Product Support Bulletin 2006-001

Maintenance of Way ~ Work Equipment Bulletin

SUBJECT: Prevent the EDC Handle from Becoming Loose

MACHINE MODEL(S): M2 Ballast Regulators

Figure 1

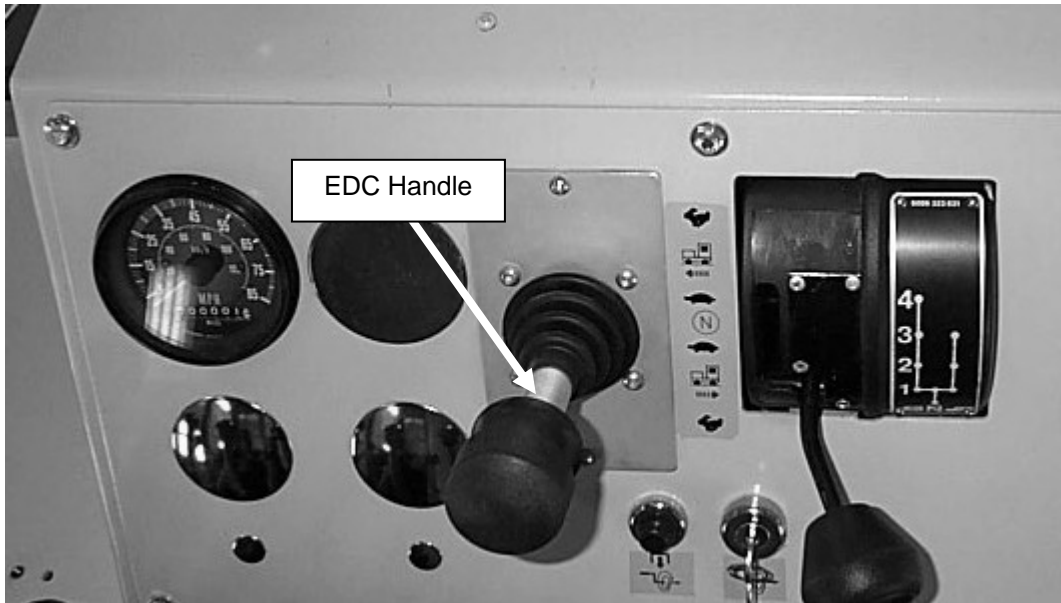
SUMMARY: The EDC is used to control forward and reverse travel. There is a possibility that the operator could twist the handle during operation causing the handle to unscrew from the EDC itself.

OPERATIONAL IMPACT: If the handle comes off of the controller, the speed and direction of travel can't be adjusted or changed with the EDC.

ACTION: The handle should be removed from the EDC and the threads in the handle and on the EDC should be cleaned of all oil and debris. Apply Loctite® 271 or 680 thread lock to the threads and reassemble handle onto EDC. The handle should be checked weekly to insure that it has not loosened during use. See Figure 1 on Page 2.

1. Remove EDC handle by turning it CCW
2. Clean the threads on the handle and EDC unit.
3. Apply Loctite® 271 or 680 thread lock to the threads of both pieces.
4. Reassemble handle onto EDC by turning it CW. Hand-tighten only!
5. Check handle weekly to insure that it has not loosened.
